Annex Residents' Association: Project Position Statement

DRAFT: 1109 Bathurst Street

Project Name: 1109 Bathurst St. ¹	Date of Application: 24 June 2020
Application Number: 20 159922 STE 11 OZ	Date of ARA Board Approval of this Position Statement: 8 April 2021
P+D² Draft recommended to Board on: 9 September 2021	P+D Review Group: David S., Terry M., Lynne D., Henry W.

Architect's rendering looking north-east

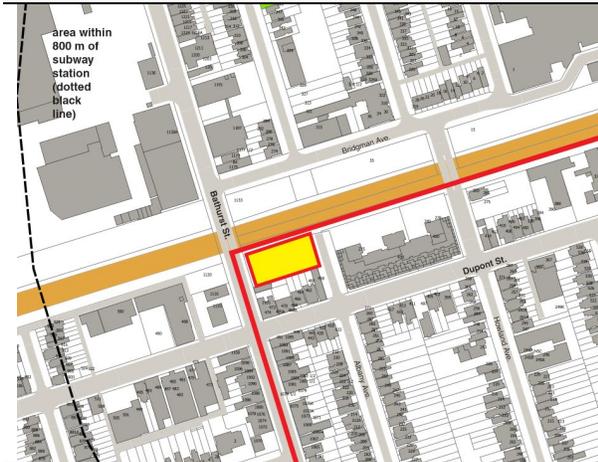
- The proposed building height, although still at 9 storeys, is now mitigated by step backs on both the Bathurst and Albany elevations, which reduce the massiveness of the building. Although 8 storeys or lower is preferred, the current proposed height, including the penthouse, is 32.3 m (top of mechanical penthouse) lower than the Bianca at 37.97 m, east of the site on Dupont.
- The floor levels are now expressed and glazing with single loaded corridors are provided on the Bathurst and Albany facades. The aforementioned step backs improve the relationship between the top two storeys and the remainder of the building.

1. Remove the proposed windows to the storage rooms on the south facade. They are gratuitous and inappropriate.
2. The base (lower two floors) of the south facade should be masonry, matching that of the north facade and creating a more robust and durable wall in anticipation of a possible future light well.

3. The proposed glazed bay on the Bathurst facade is out of scale. The bay should be removed and the design of the Bathurst facade should more closely resemble that of the Albany facade."
